Re: 2026.IE30.8 - Queen's Park North Donation - Concept Plan Update Report

Appendix 2 - Concept Plan

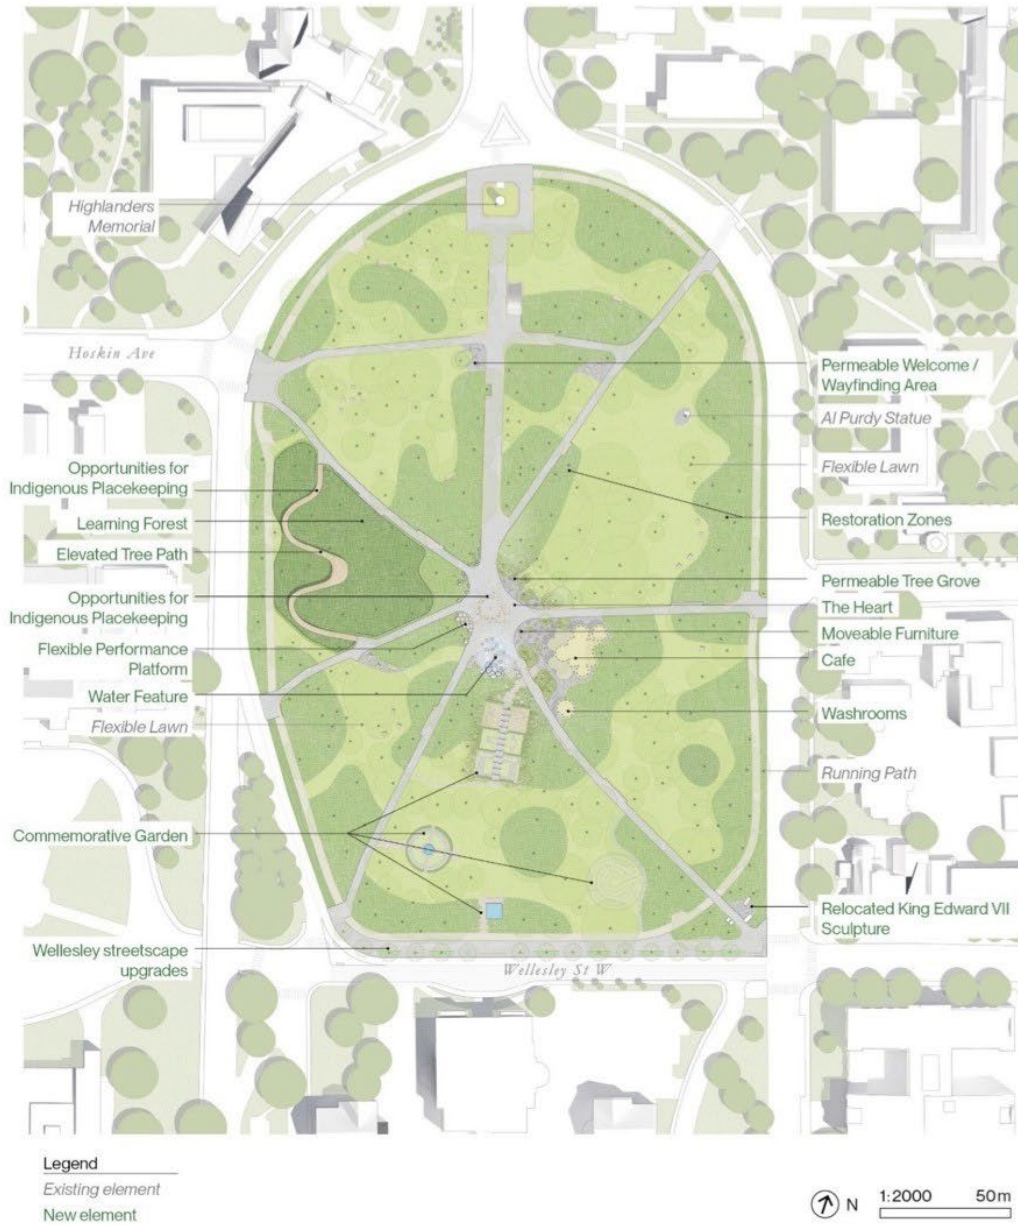
It is my understanding that you will be reviewing the staff report of June 8 on the redevelopment of Queens Park North which was prepared for the June 10 meeting of the Infrastructure and Environment Committee. Attached is the concept plan regarding the current state of the proposal after many months of work. It includes no dimensions and has not been shared with the public until the publication of the report, two working days before City Council. The staff report includes, as part of the program for the park redevelopment, a 140 seat café (40 seats inside and 100 seats outside) represented on this diagram as a bubbled circle. City staff at the June 10 meeting felt that the café would not pose a threat to the health of the trees. This view however was based on the very incomplete and undeveloped information at hand. With respect to the café, the following information was not available even though this information is absolutely necessary in order to evaluate its impact on the existing trees and the character and ambiance of Queens Park North.

1. Scaled plan drawings of the café and support spaces.
2. Drawings illustrating the infrastructure required to support the delivery of food and other supplies, likely in the form of extensive paved area to accommodate delivery vehicles and their turnaround space.
3. Drawings indicating the infrastructure required for waste removal. Is it private or city contracted removal?
4. Infrastructure for site services (water, sewer, power.....) and the location of such.
5. Construction impact, staging area, vehicular access.....
6. Scaled drawing of the outdoor eating area.
7. Fire truck access including turnaround space.

Diagram from the May 11, 2026 Public Meeting slide show.

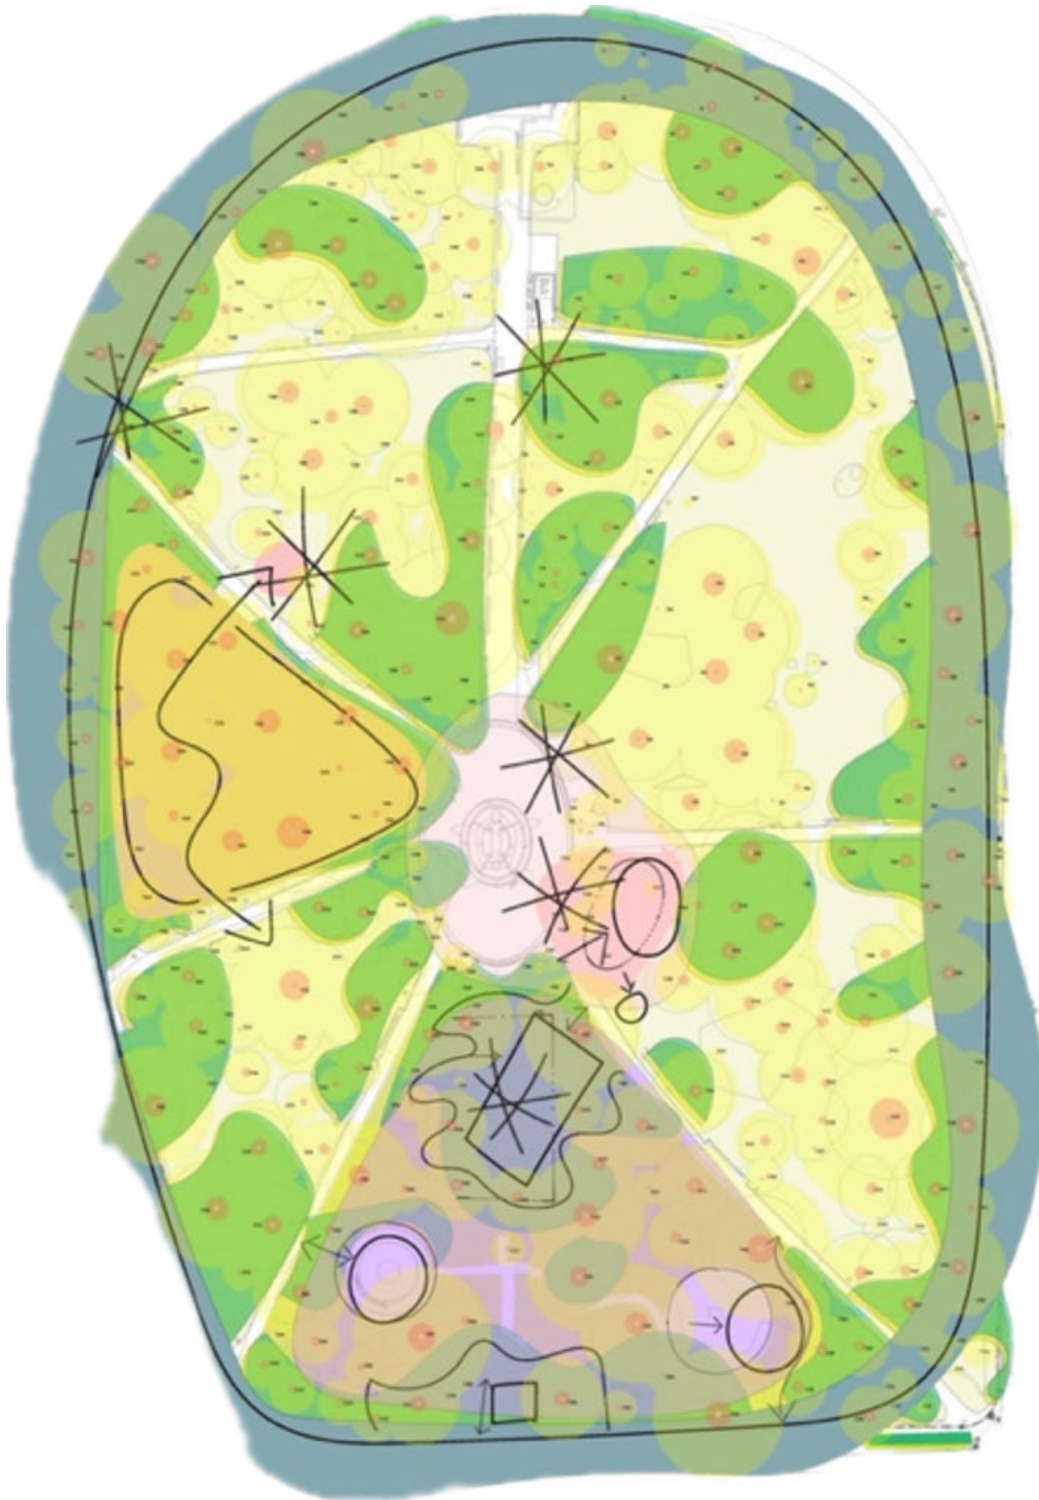
The process over the last many months has been disingenuous. At the urging of FoQPN and the City of Toronto Design Review Panel, a Forest Management Plan (FMP) was undertaken. The drawing shown to the Design Review Panel is also attached. It is no more than a squiggle diagram. To date, the design adjustments resulting from the FMP have only been minor tweaks. Virtually none of the major concerns raised by FoQPN have been addressed. More detailed drawings that have existed for some time have been withheld from FoQPN and the public creating a feeling of profound mistrust. For true public engagement regarding the café it would
